TO: Land Development Consultants
FROM: Julia Duncan, Associate Planner
DATE: May 19, 2022
SUBJECT: SP21-138; Auburn Hills Centre L4 - Circle K
Review Comments 01

CIRCLE K SITE DEVELOPMENT PLAN

PROJECT:
CIRCLE K STORES INC.
SITE DEVELOPMENT PLAN
MAINSTREET & JORDAN
TOWN OF PARKER, CO

LANDSCAPE DETAILS
 LS02
 SHEET 4 OF 4
 TOWN FILE NO#

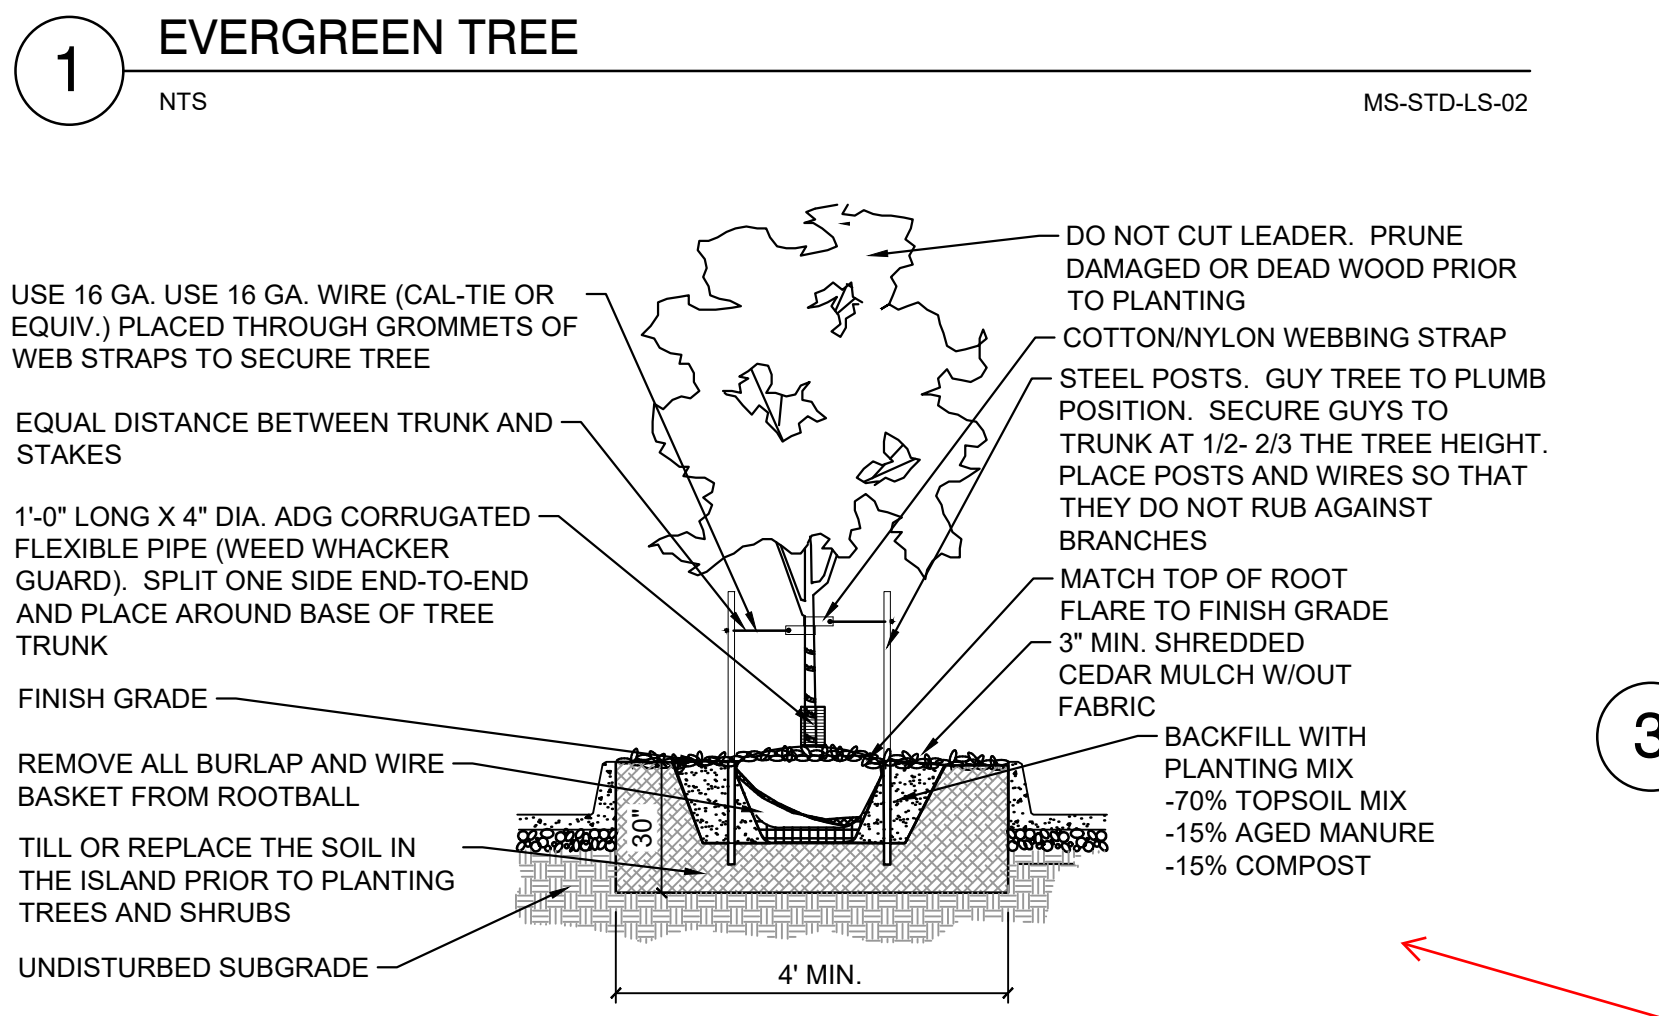
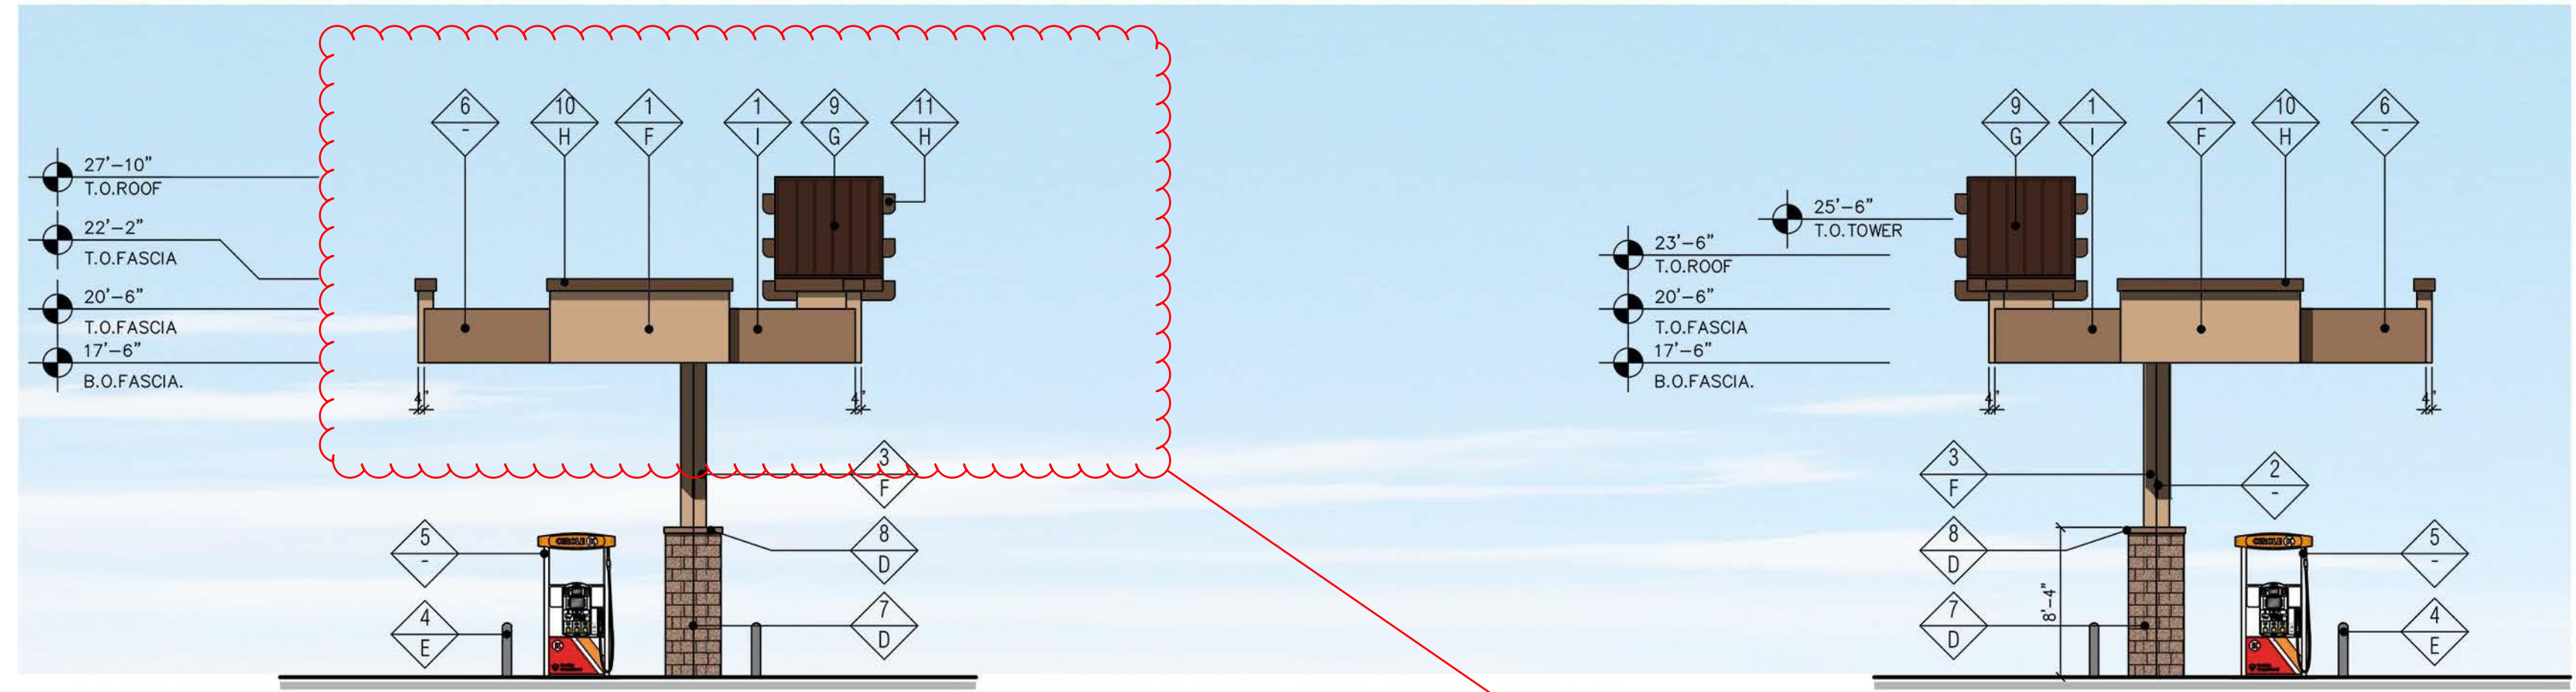
Must use Town of Parker planting standards for trees and shrubs verbatim: <http://parkeronline.org/DocumentCenter/View/400/Construction-Specifications?bidId=>

← Replaced

3 "SIDE" ELEVATION (SOUTH)
SCALE: 1/8" = 1'-0"

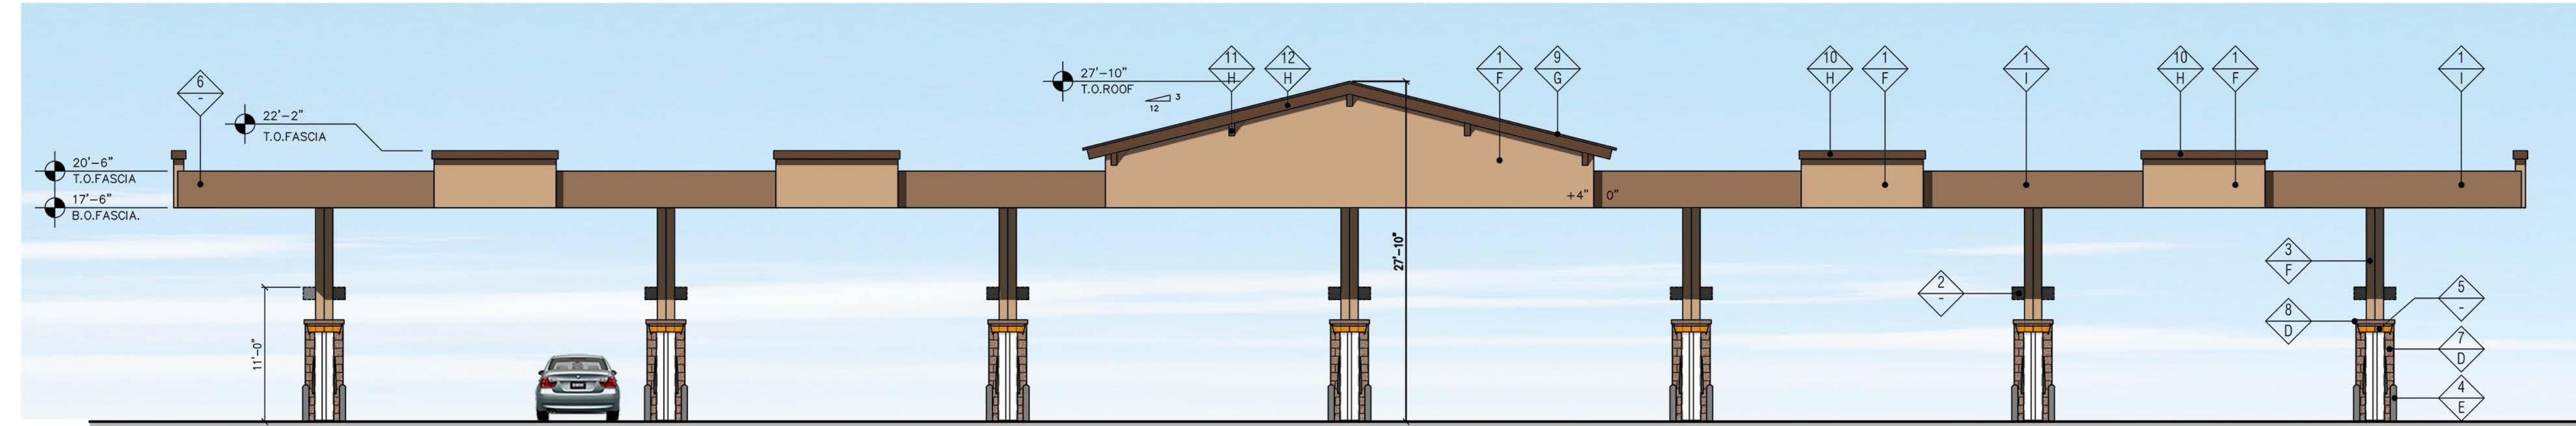
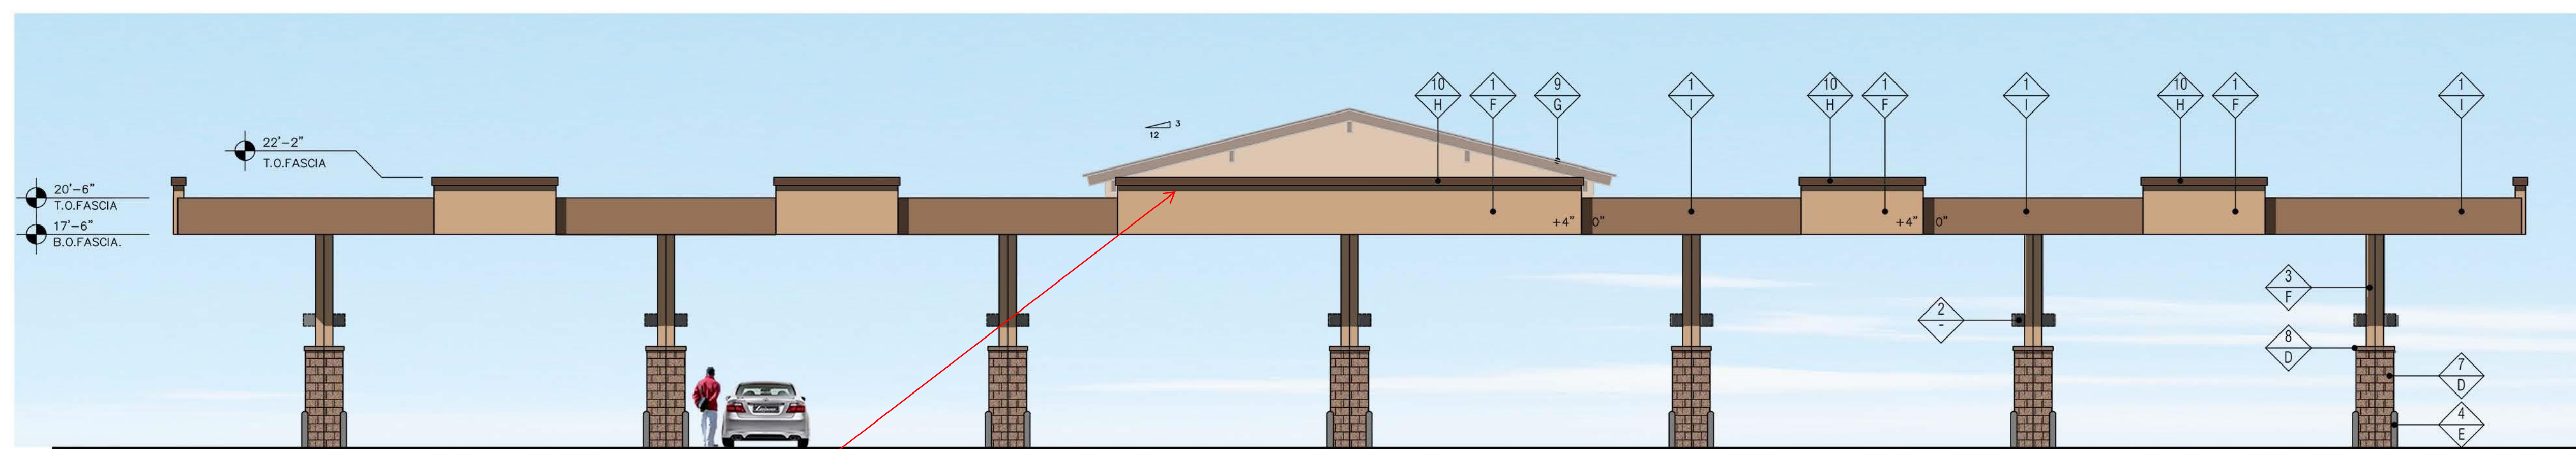
The North and South elevations present oddly-consider adding a similar pitched roof to seem more cohesive

Should mimic West elevation

Response: Added pitched roof for both North & South elevations. See revised fuel canopy elevations

Response: Added gable roof to similar to West elevation. See revised fuel canopy exterior elevation.

1 WEST - FRONT ELEVATION
SCALE: 3/16" = 1'-0"

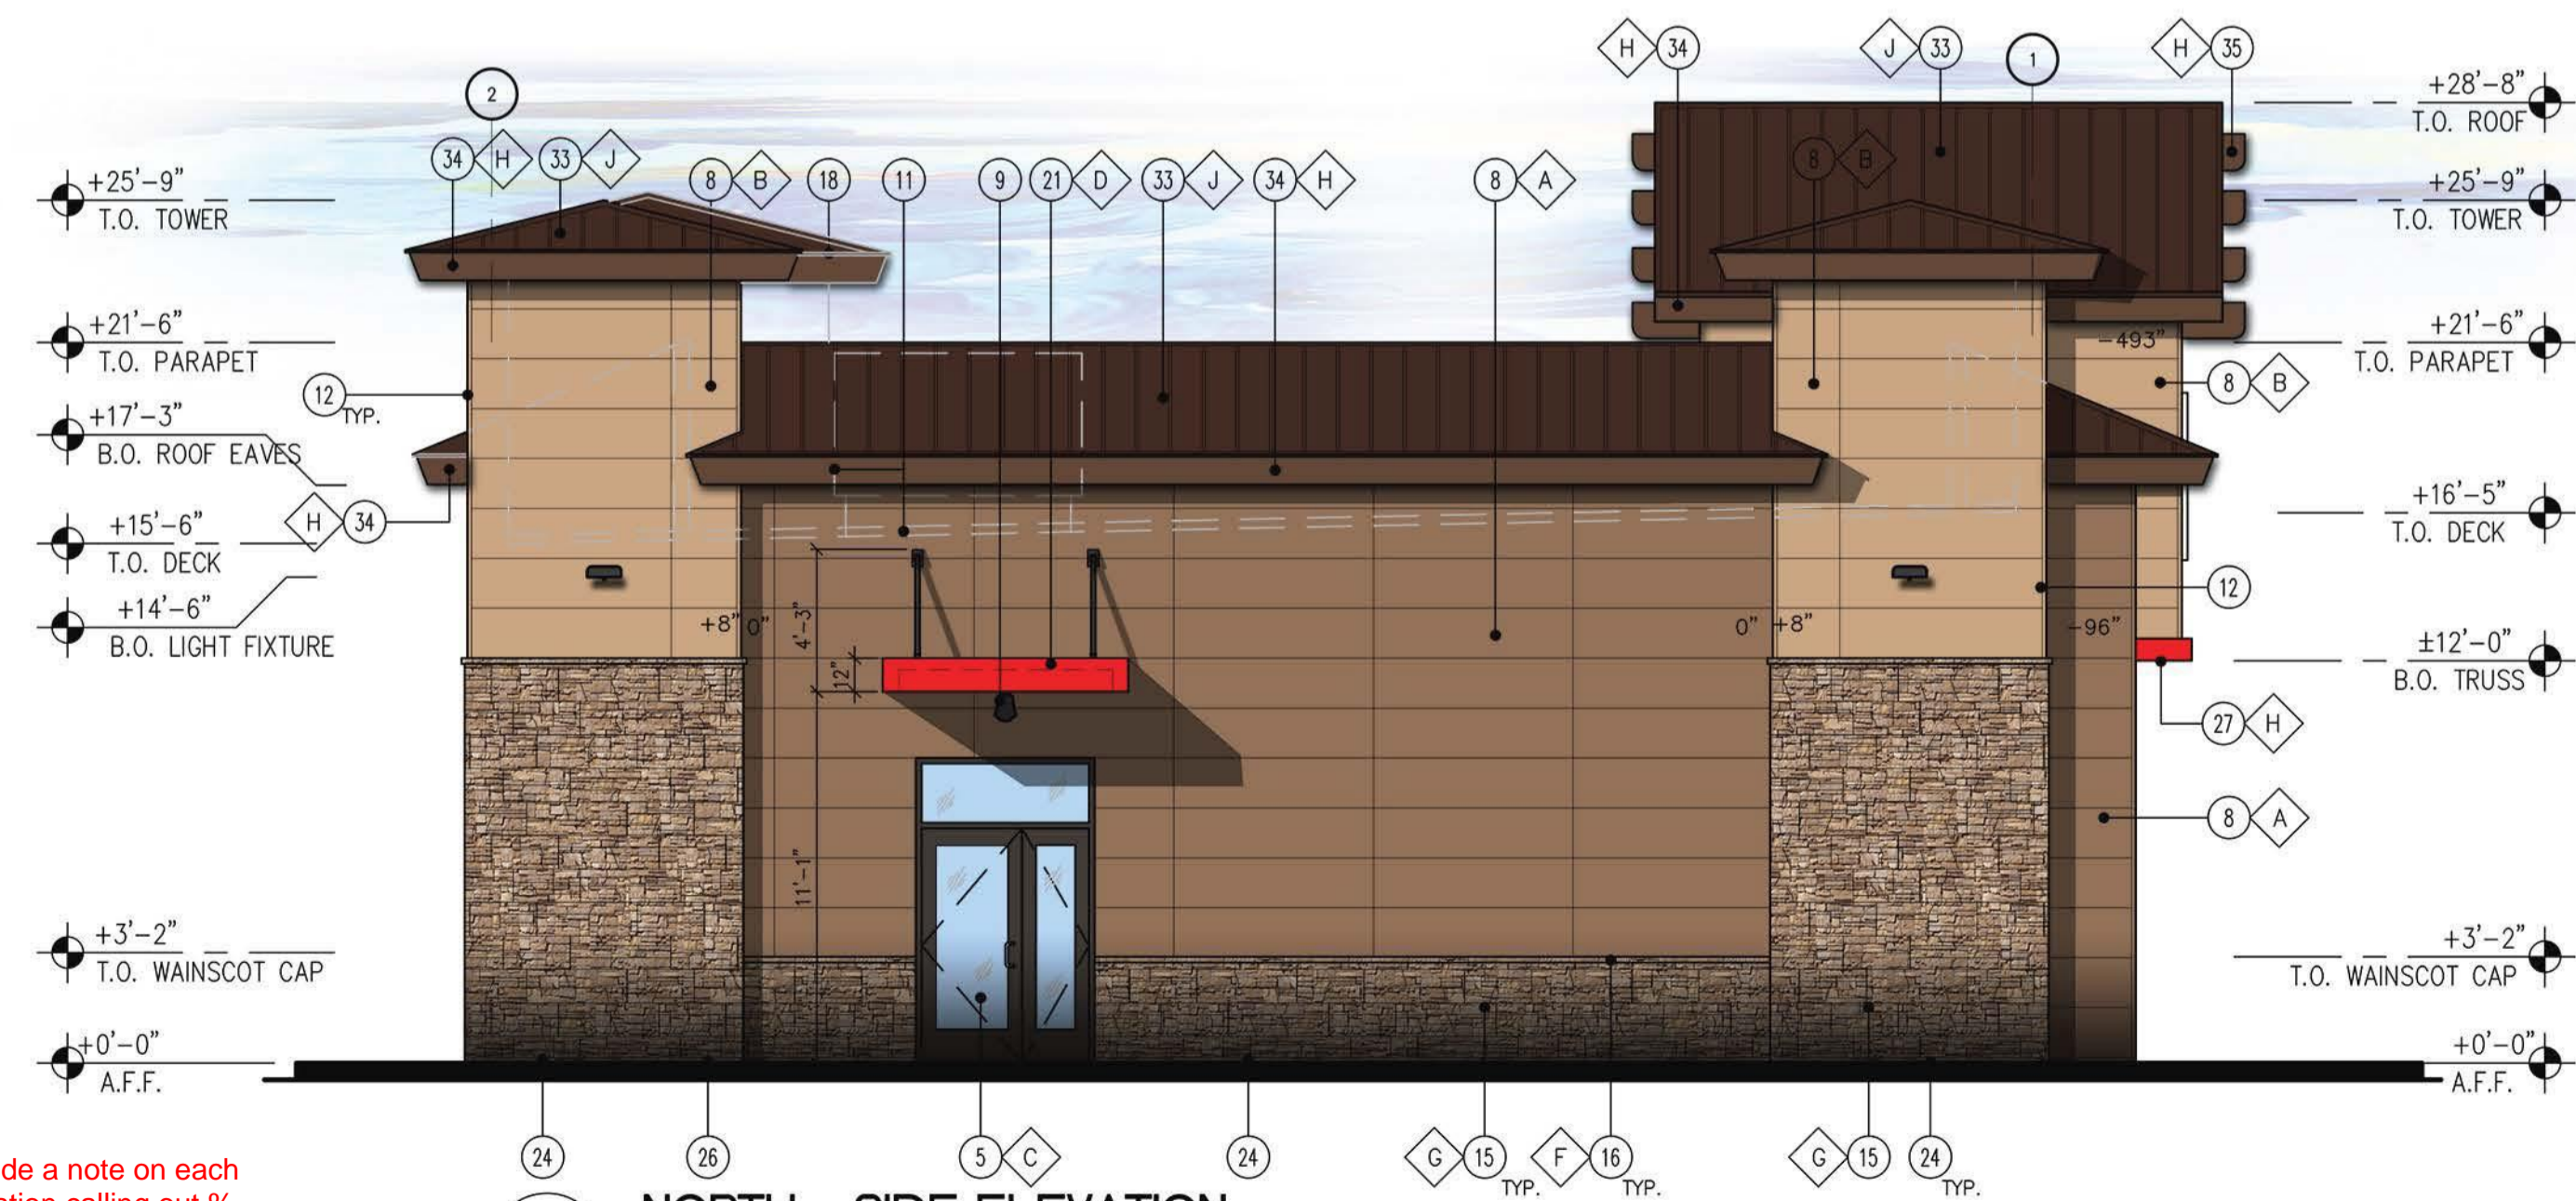
Include a note on each elevation calling out % of transparency as calculated off the total facade of the building and the percentage that falls between 2 and 8 feet

Response: Added % of transparency calculation at the bottom right corner
